CHANGES FOR SUPPLEMENT 1

Summary: Rockwell Collins Information Management Services (IMS) has identified an error in Figure 1.7-3 of Attachment 1.7.2.1 of ARINC Characteristic 771-1. The AEEC staff will correct this error in the next release of this ARINC Standard.

ARINC Characteristic 771-1: Low-Earth Orbiting Aviation Satellite Communication System

Figure 1.7-3: External RF Block – Middle Plug Diagram

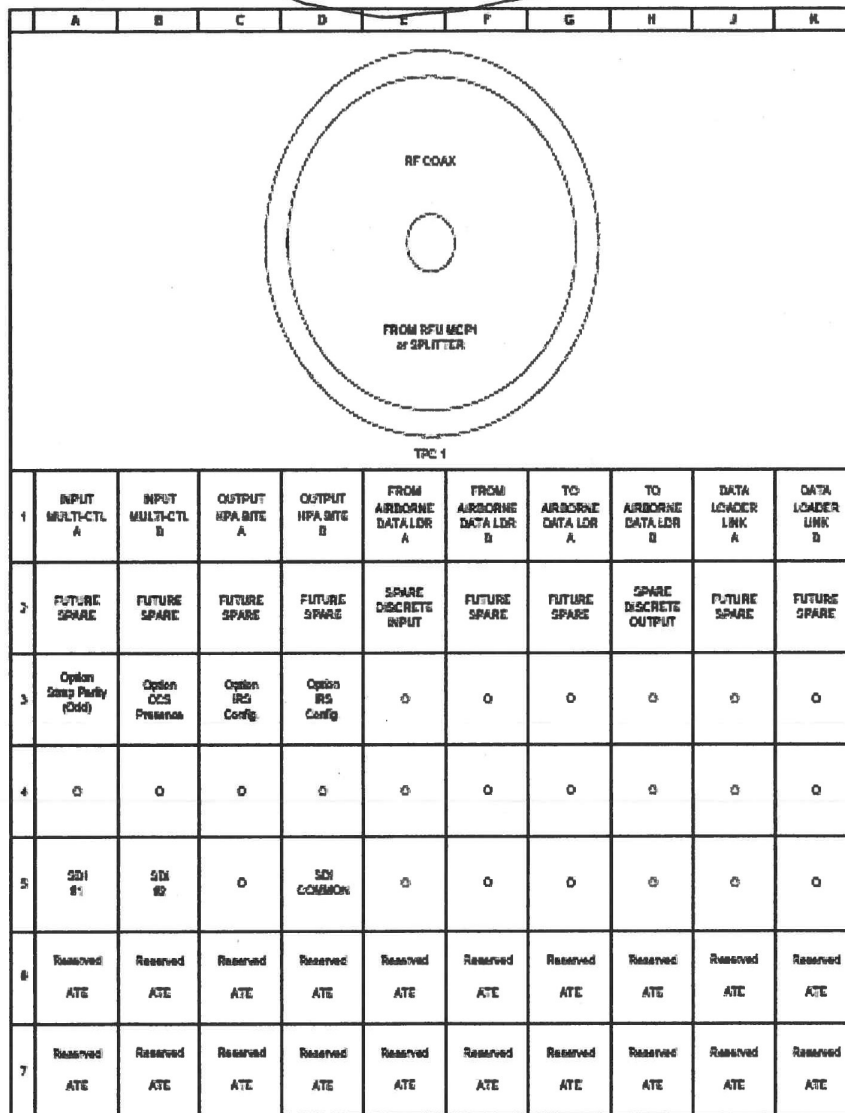
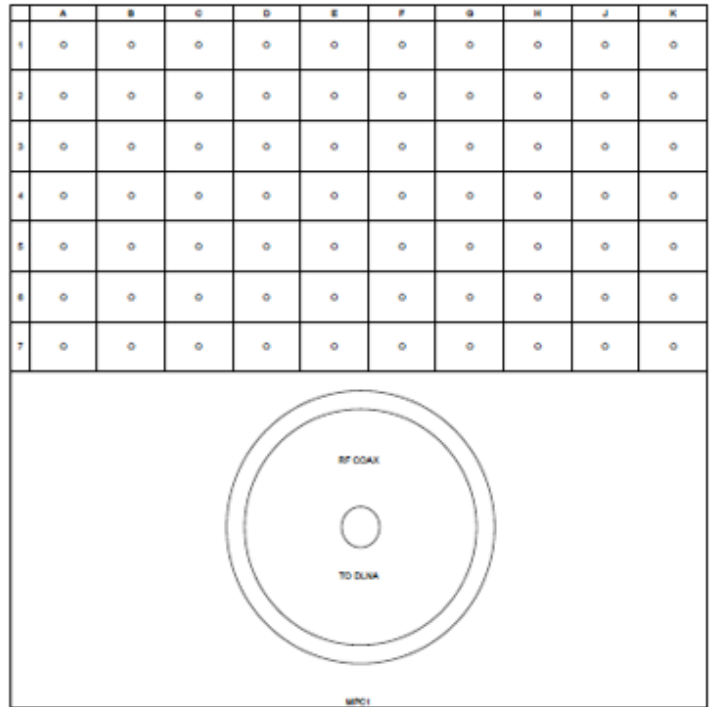
ARINC Industry Activities has confirmed that Figure 1.7-3 – External RF Block – Middle Plug Diagram is in error. The diagram incorrectly illustrates the Top Plug twice. Figure 1.7-3 will also be corrected as described below.

The graphic of the RF Block Middle Plug is incorrect... Top Plug duplicated. Top Plug is correct on previous page. The proper graphic has the coax at the bottom of the plug segment, a different insert part number.

*See attached
Graphic shows RF Block Top Plug duplicate at previous page. S/B Middle Plug which has COAX*

4. Recommended Correction *at bottom of the connector*

The following is the correct diagram for the Middle Plug of the External RF Block

(Correct Middle Plug Diagram)
